DEPARTMENT OF ENVIRONMENTAL MANAGEMENT
 OFFICE OF WATER RESOURCES
 FRESHWATER WETLANDS PROGRAM
 REVIEWED SITE PLAN APPLICATION NO. 07-0227
 DATED JUL - 9 2007
 SEE LETTER OF SAME DATE.

SCALE: 1" = 40' UNLESS OTHERWISE NOTED OR CHANGED BY REPRODUCTION	DRAWN BY: KMB	WETLANDS PRELIMINARY DETERMINATION PLAN PREPARED FOR: DAVID ROUNDS	JOB 29 MORIN
EARTH WORKS ENGINEERING, INC. 69 SPRING GROVE ROAD CHEPACHET, RHODE ISLAND 02814 (401) 667-0861	PROJECT CHECK: KMB		ASSESSOR'S PLAT #11, LOT #28/#29 GLOUCESTER, RHODE ISLAND
	DATE: MAY 18, 2007		SHEET 1 OF 1

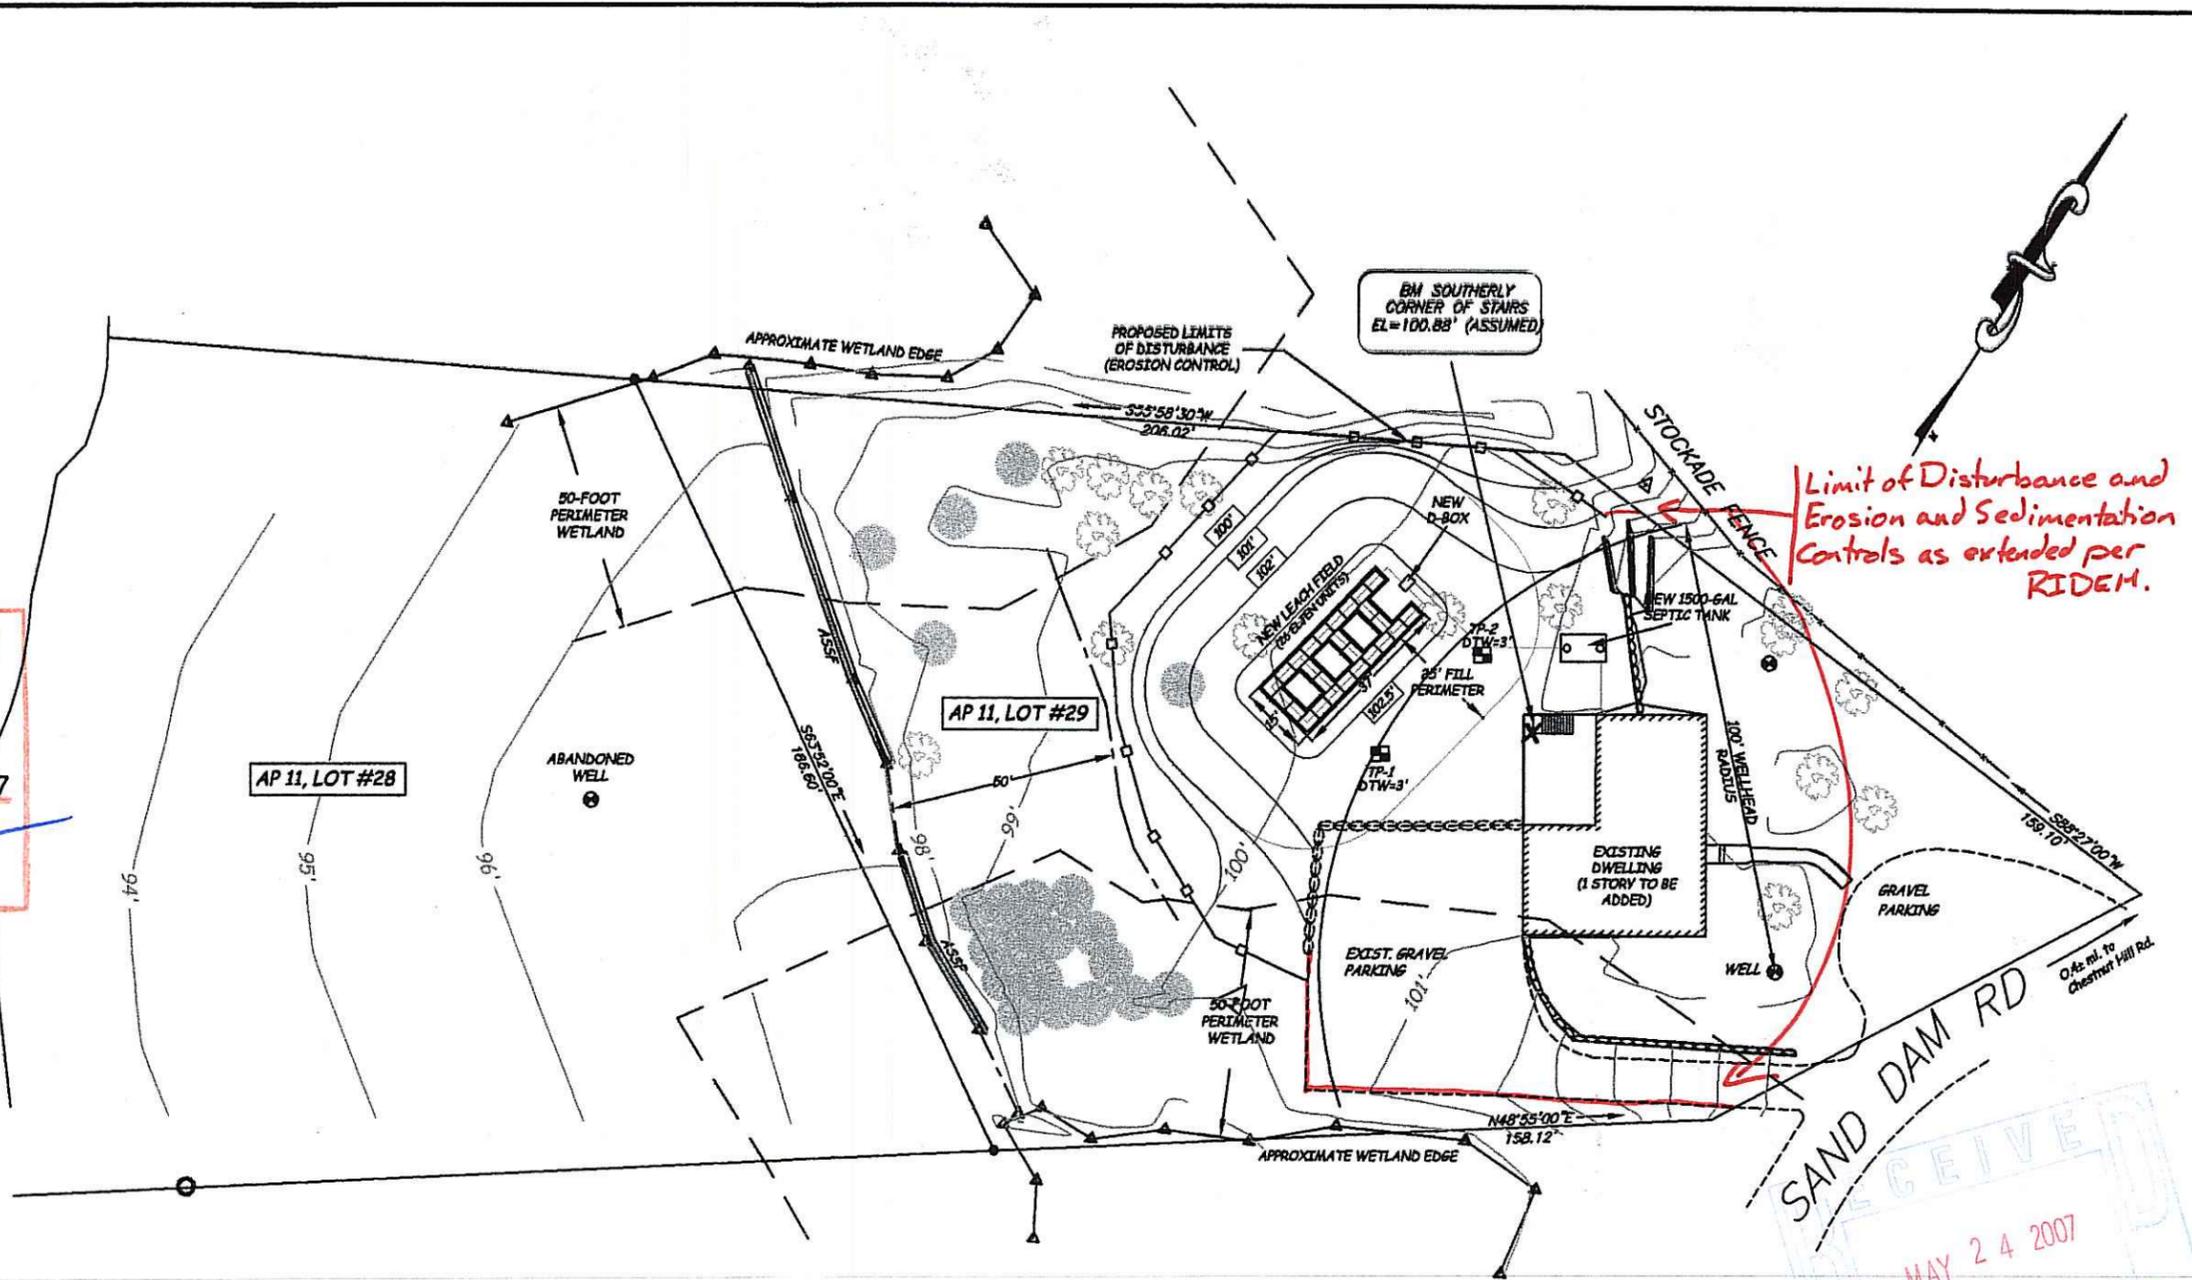
Limit of Disturbance and Erosion and Sedimentation Controls as extended per RIDEM.
